Model: Adonis-C2 SR760		Date: 28-Jun-01	No.: MB352001
Modified Article: Caster		Prepared by: E. Fukuyama	
From: Technical Services Dept., GTS Division			
Reason for Modification:	<input checked="" type="checkbox"/> Parts catalog correction <input type="checkbox"/> To facilitate assembly <input type="checkbox"/> Part standardization	<input type="checkbox"/> Vendor change <input type="checkbox"/> To improve reliability <input type="checkbox"/> Other	<input type="checkbox"/> To meet standards (      )

Model: Adonis-C2 SR760		Date: 30-Aug-01	No.: MB352002
Modified Article: Cam - Paper Exit Unit		Prepared by: E. Fukuyama	
From: Technical Services Dept., GTS Division			
Reason for Modification:	<input type="checkbox"/> Parts catalog correction <input type="checkbox"/> To facilitate assembly <input type="checkbox"/> Part standardization	<input type="checkbox"/> Vendor change <input checked="" type="checkbox"/> To improve reliability <input type="checkbox"/> Other	<input type="checkbox"/> To meet standards ( )

Model: Adonis-C2 SR760		Date: 30-Aug-01	No.: MB352003
Modified Article: Base-Lower Tray and Side Plates		Prepared by: E. Fukuyama	
From: Technical Services Dept., GTS Division			
R

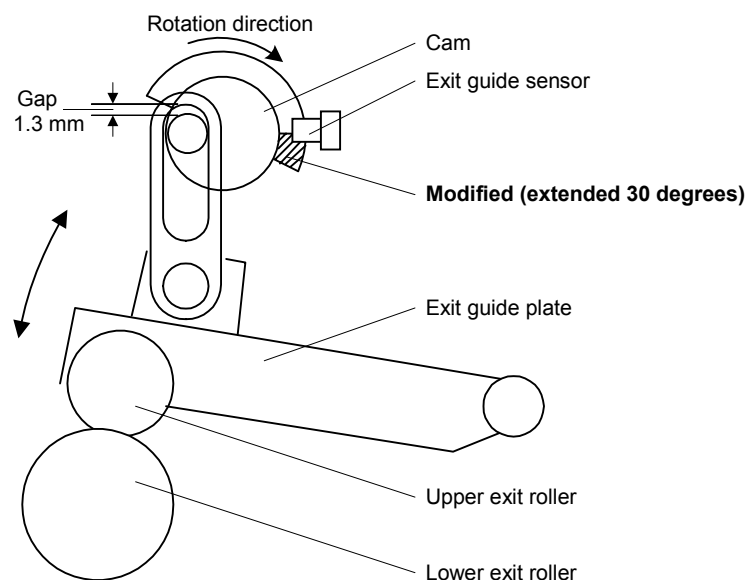
The following should be corrected. Please correct your parts catalog.

Old part number	New part number	Description	Q'ty	Page	Index
B3521130	G5651140	Caster	1-2	21	6

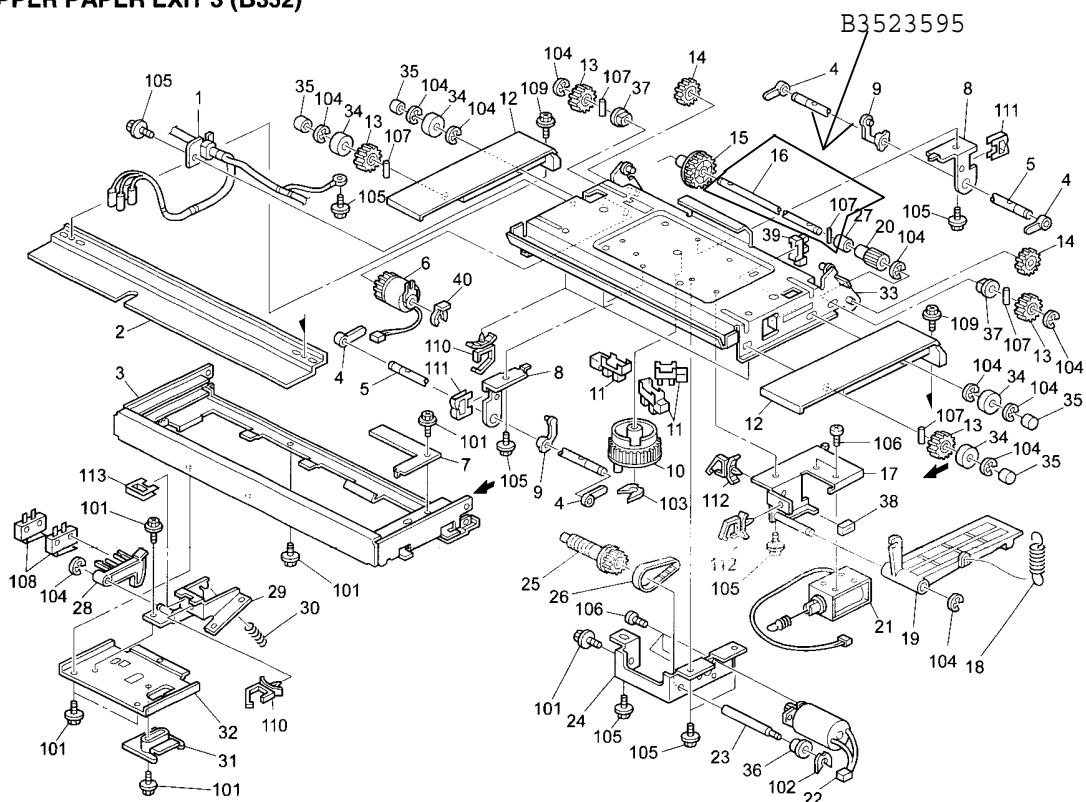
Although the loading capacity of the Lower Tray is 750 sheets according to the specifications, there are cases where customers load up to 1500 sheets into the tray, causing the Side Plate to deform from stress. When the Upper Tray is then selected in this condition, the Lower Tray's Side Plate catches on the overflow sensor, damaging the sensor.

To ensure that the Side Plate does not deform even under such conditions, the following parts have been further strengthened.

Old part number	New part number	Description	Q'ty	Int	Page	Index
B3523810	B3523812	Side Plate – Lower Front	1-1	O/O	33	13
B3523820	B3523822	Side Plate – Lower Tray	1-1	O/O	33	16
B3523831	B3523830	Base – Lower Tray	1-1	O/O	33	18

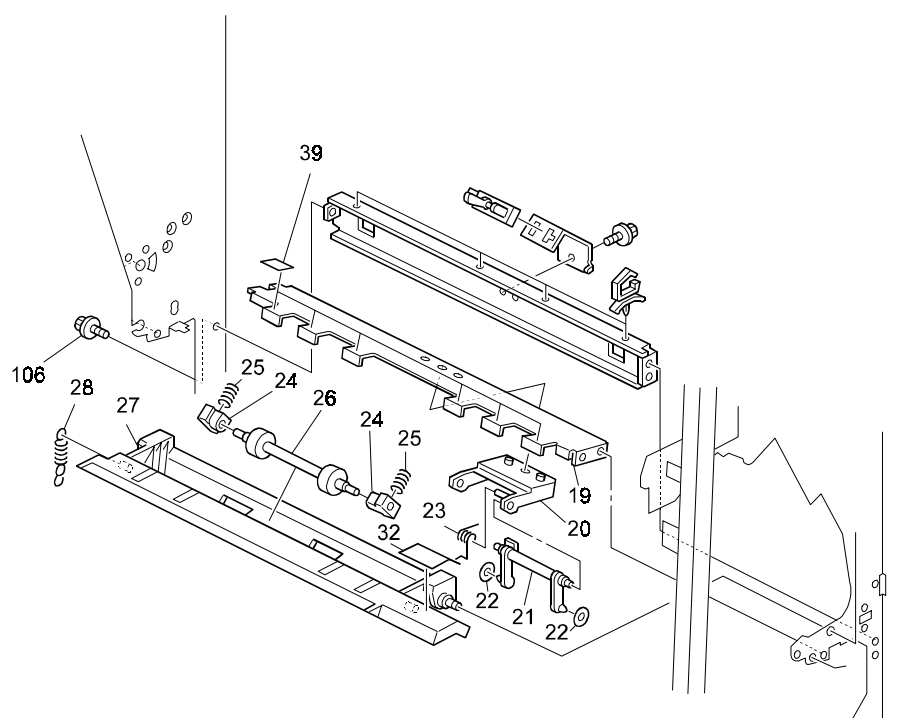
Please apply the following P/N corrections to your Parts Catalogs:

Old part number	New part number	Description	Q'ty	Int	Page	Index	Note
B3525500	B3525520	Main Control Board	1-1		39	1	
50530447	G8003089	Bushing – 6mm	1-1		11	20	
B3522220	G5652221	Stay - Guide Holder	1-1		17	19	Fig 1
	G5652222	Mylar – Guide Holder	0-6		17	39	Fig 1
